Revisions:	Date:
ADDENDUM 1	08-09-24
ADDENDUM 2 (NO STRUCTURAL CHANGES)	XX-XX-XX
ADDENDUM 3	01-17-25

Drawing Title: **FOUNDATION AND SLAB PLANS**

Project Title: **DESIGN REPLACE BOILER PLANT**

Drawing Number: **SB101**

F1 GROUND FLOOR FOUNDATION PLAN
1/8" = 1'-0"

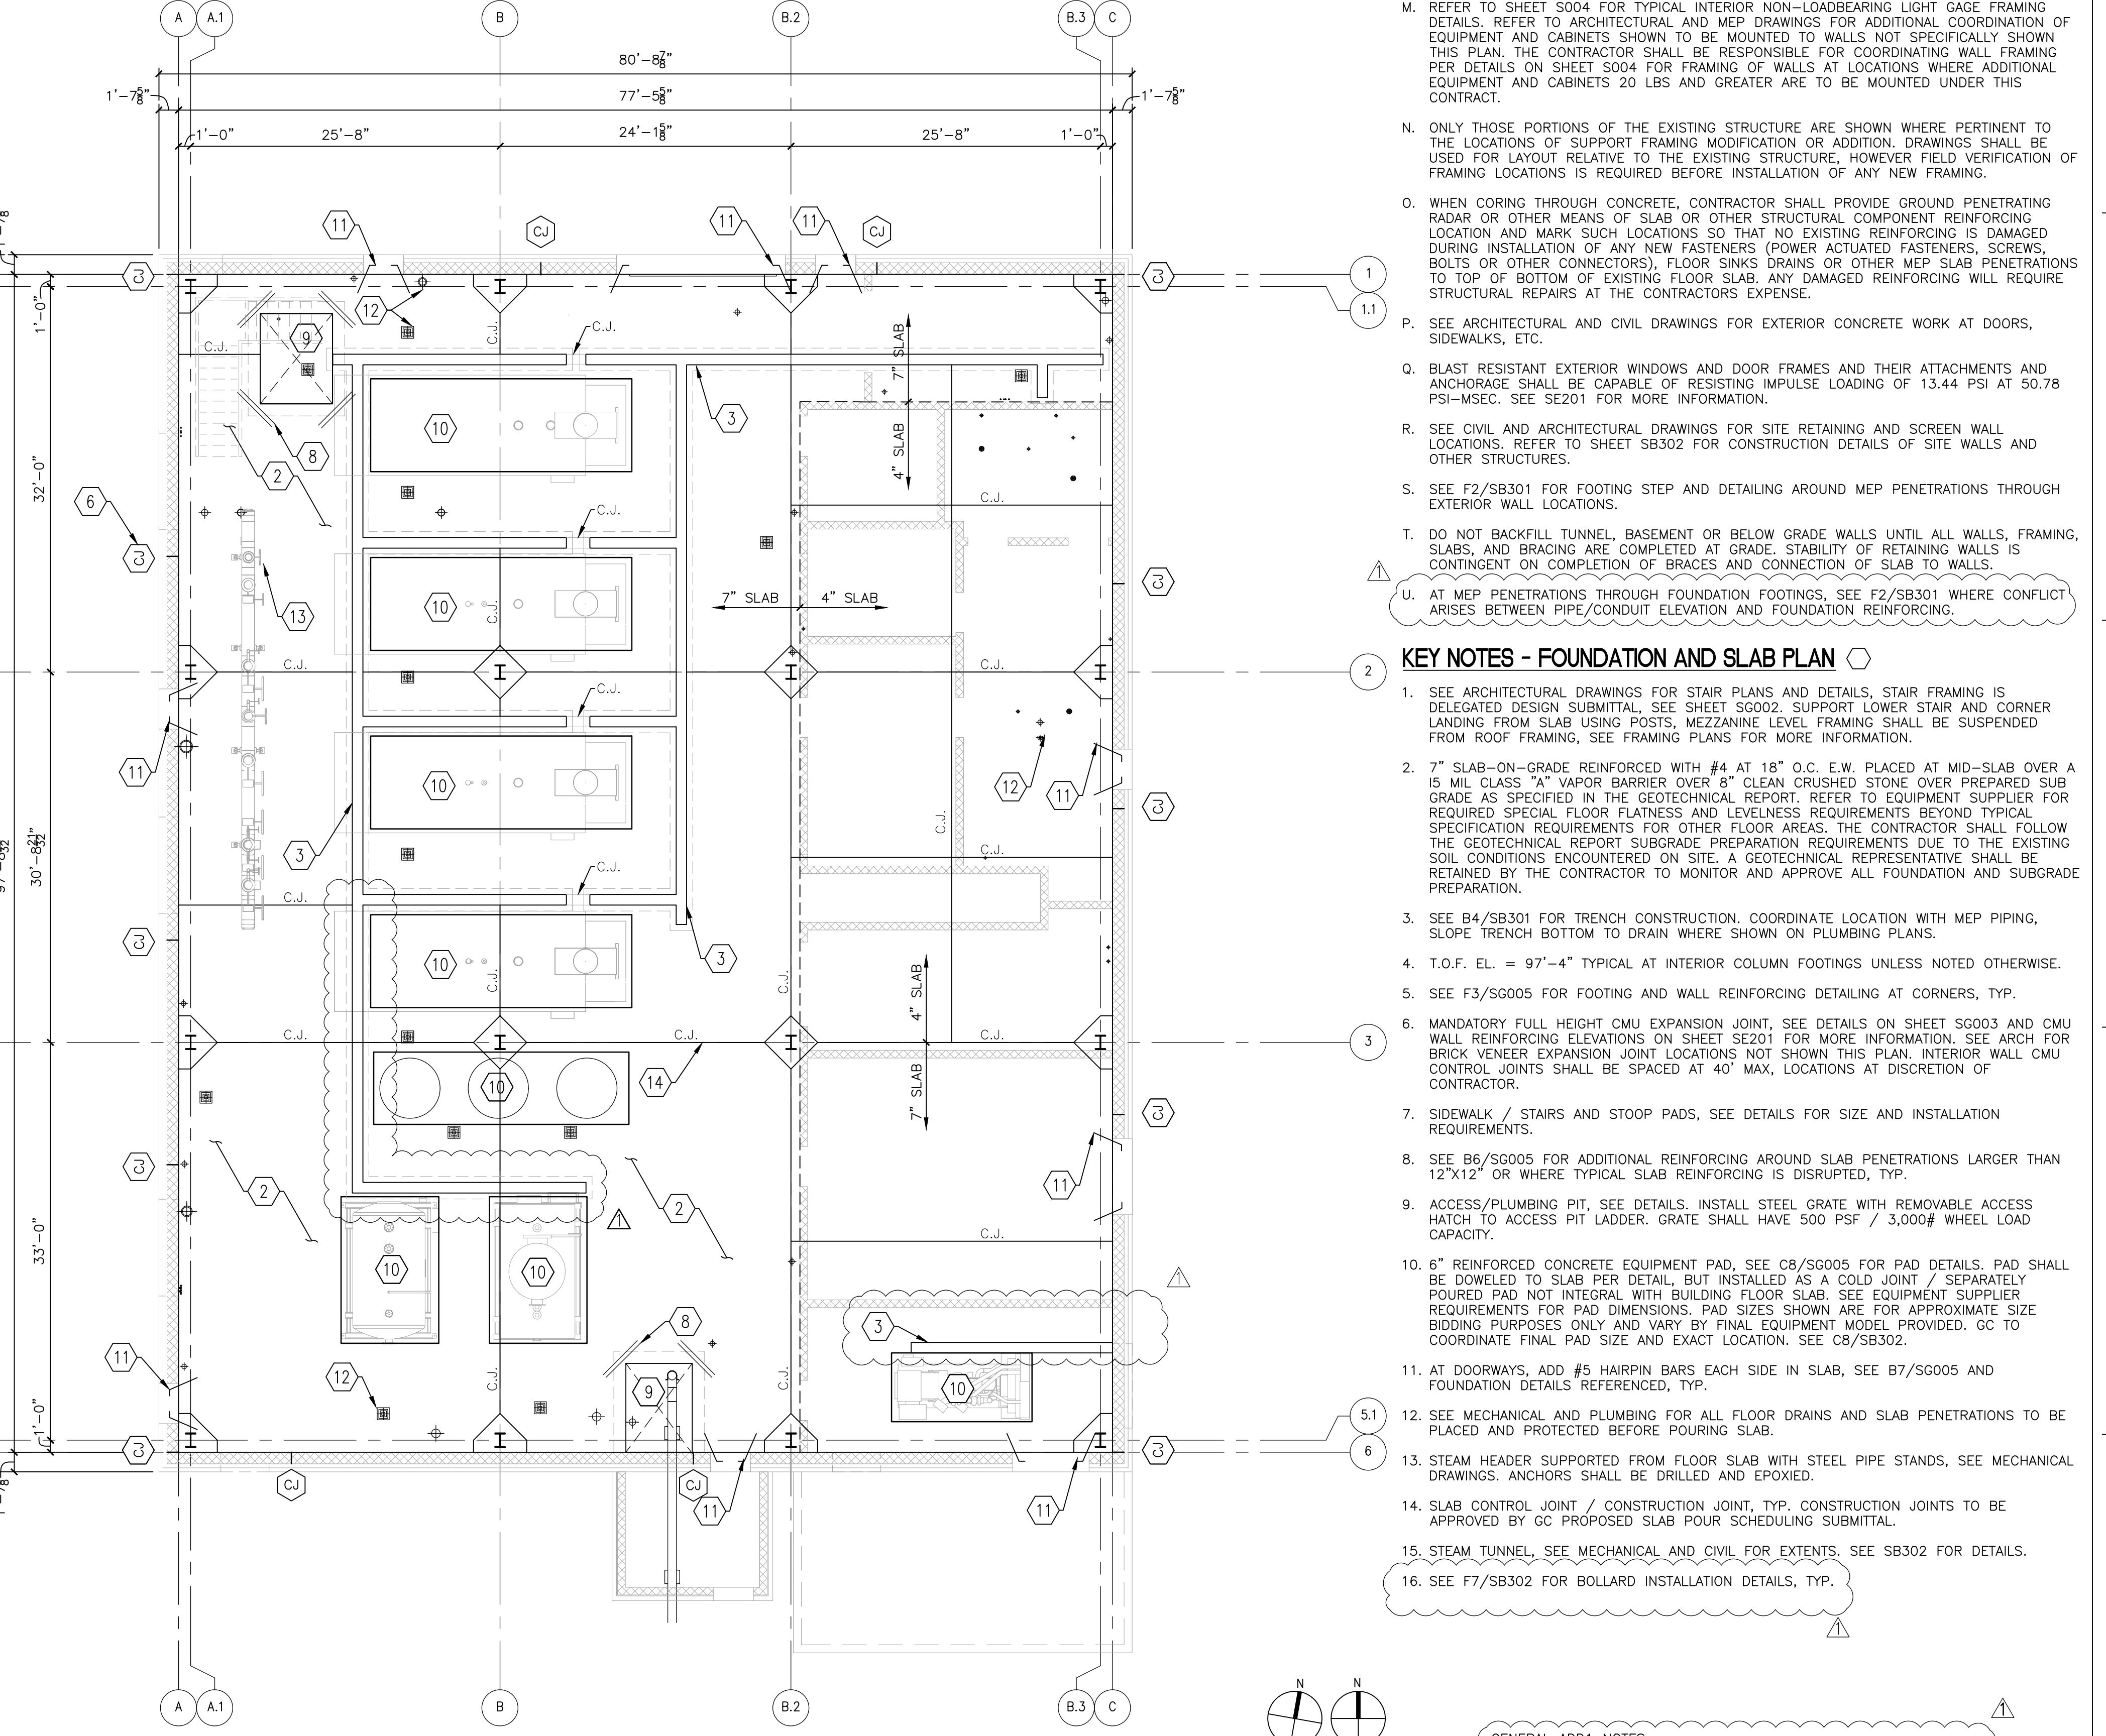
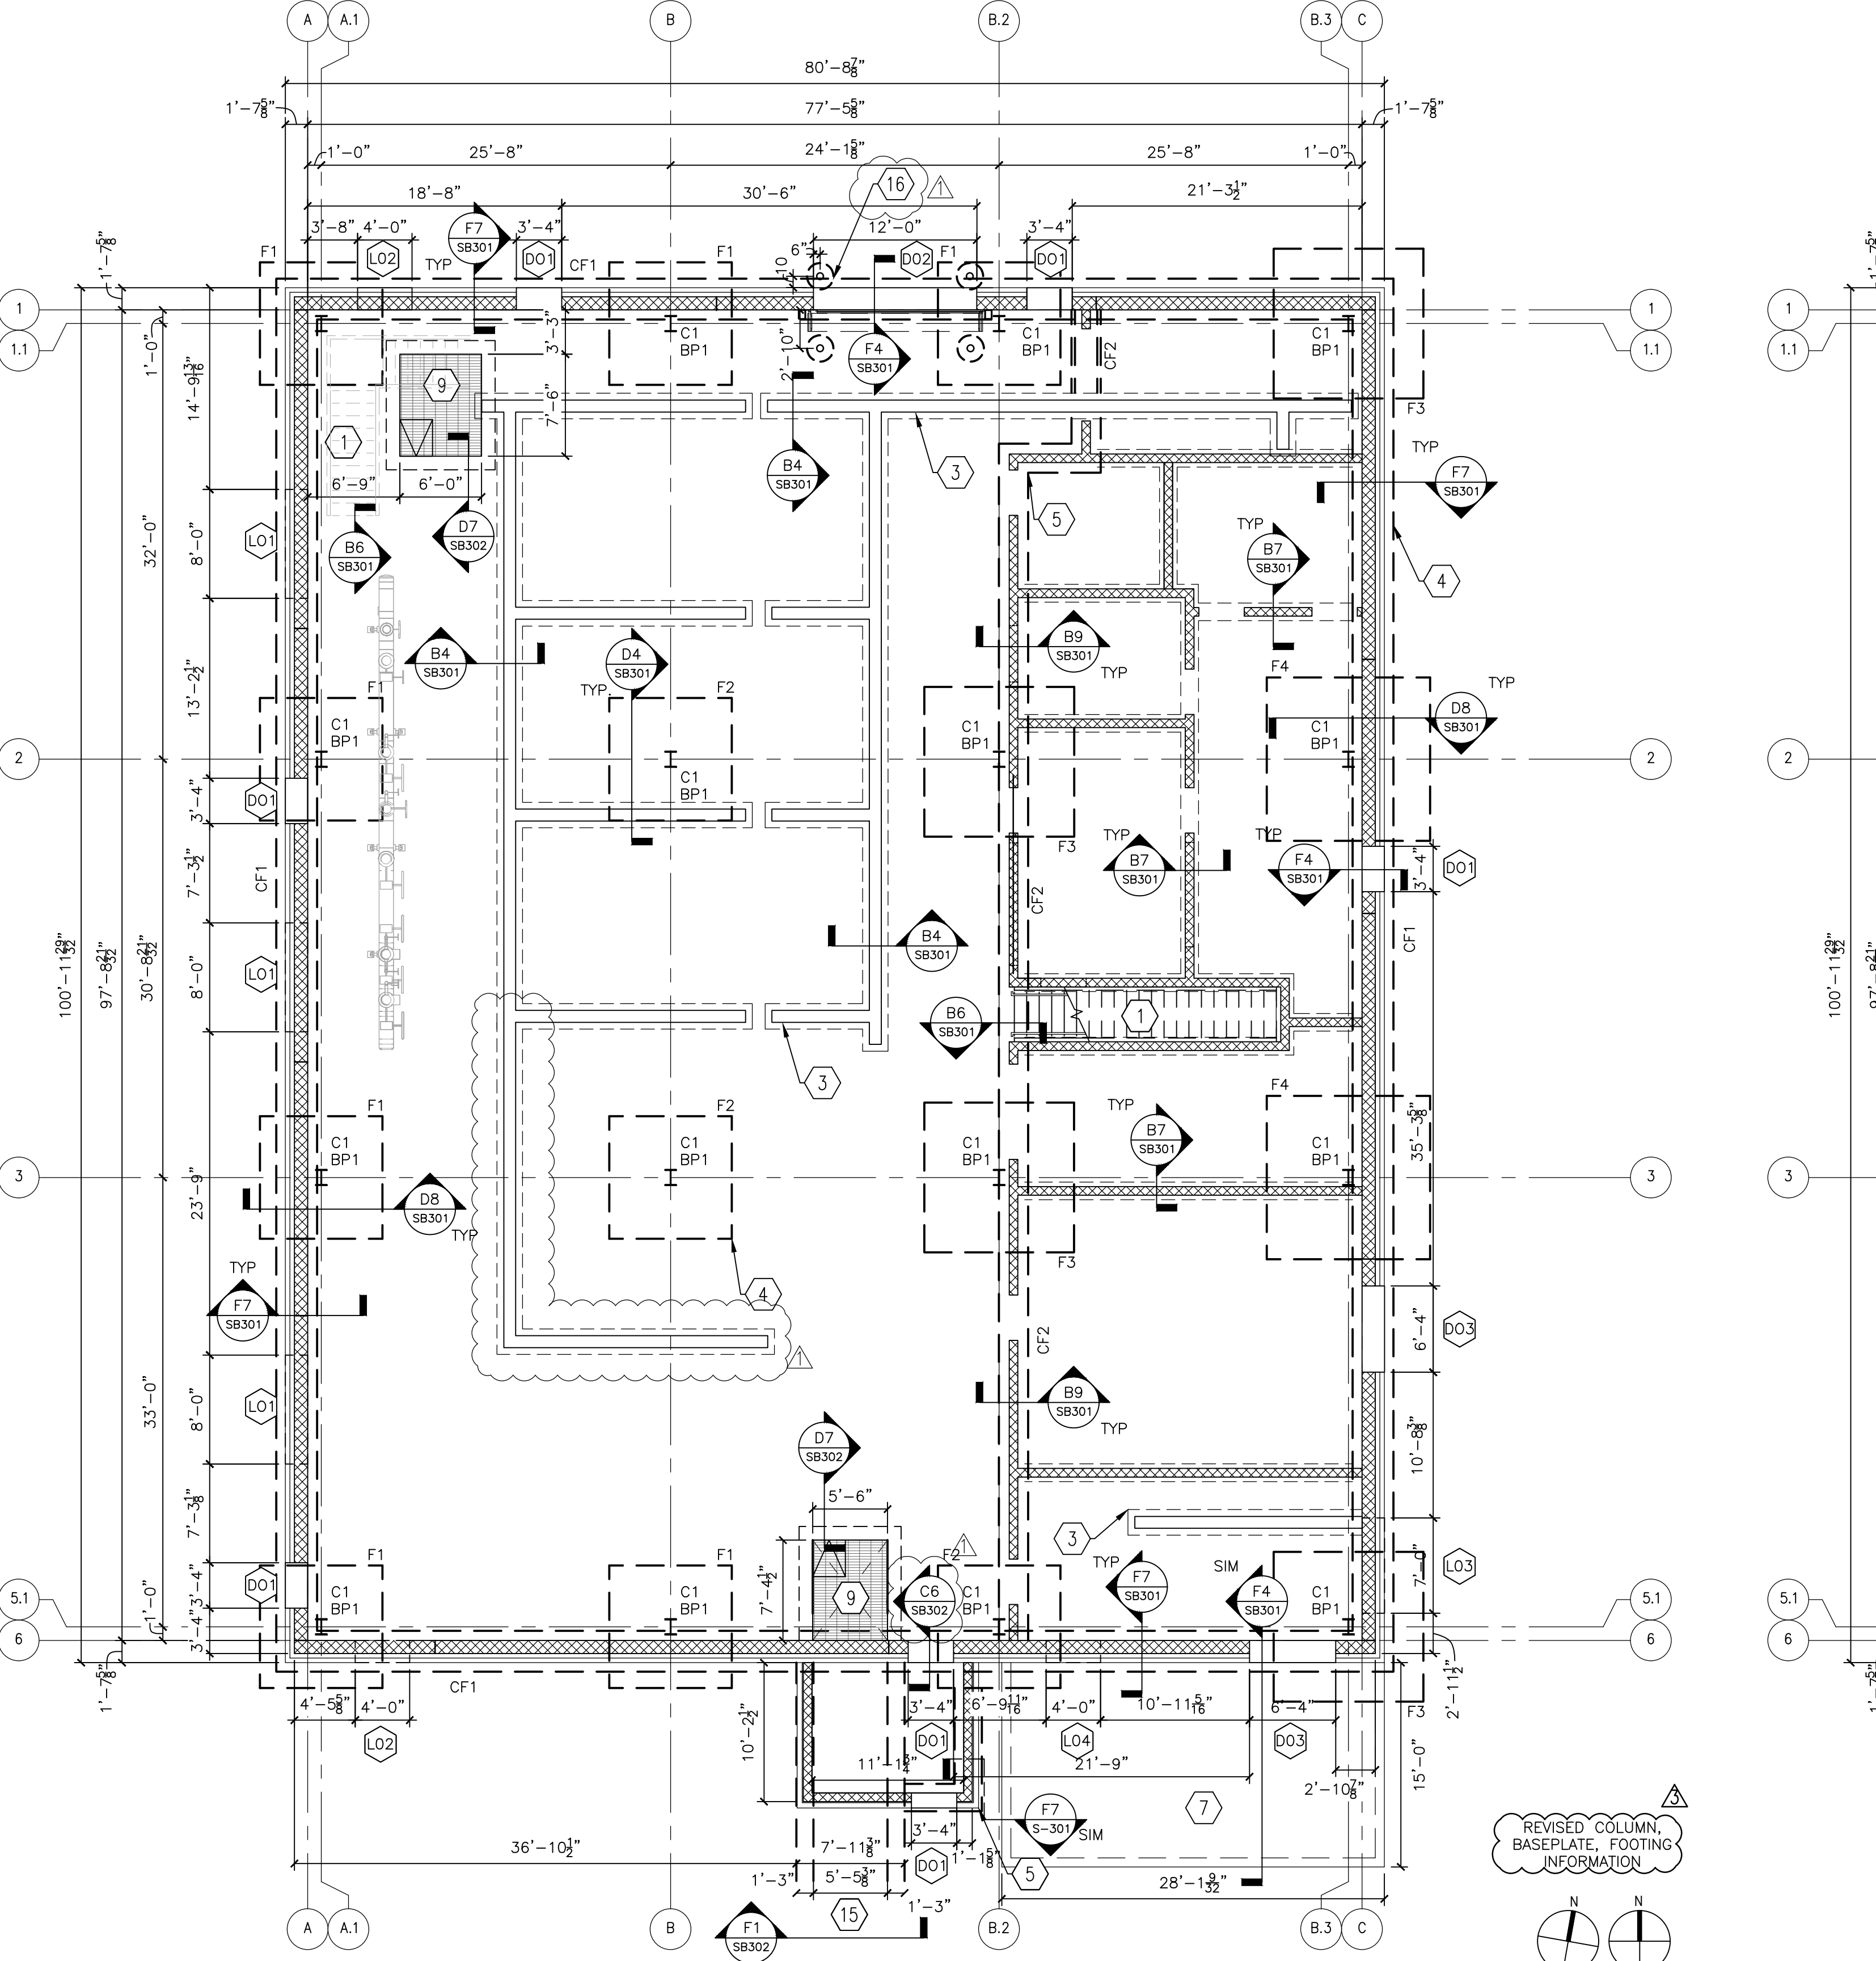
GENERAL ADD1 NOTES:
 ADDED TYP WHERE APPLICABLE TO NOTES AND DETAIL FOR CLARITY.
 ADDED KEYNOTE CALL-OUTS TO TYP. ITEMS FOR CLARITY
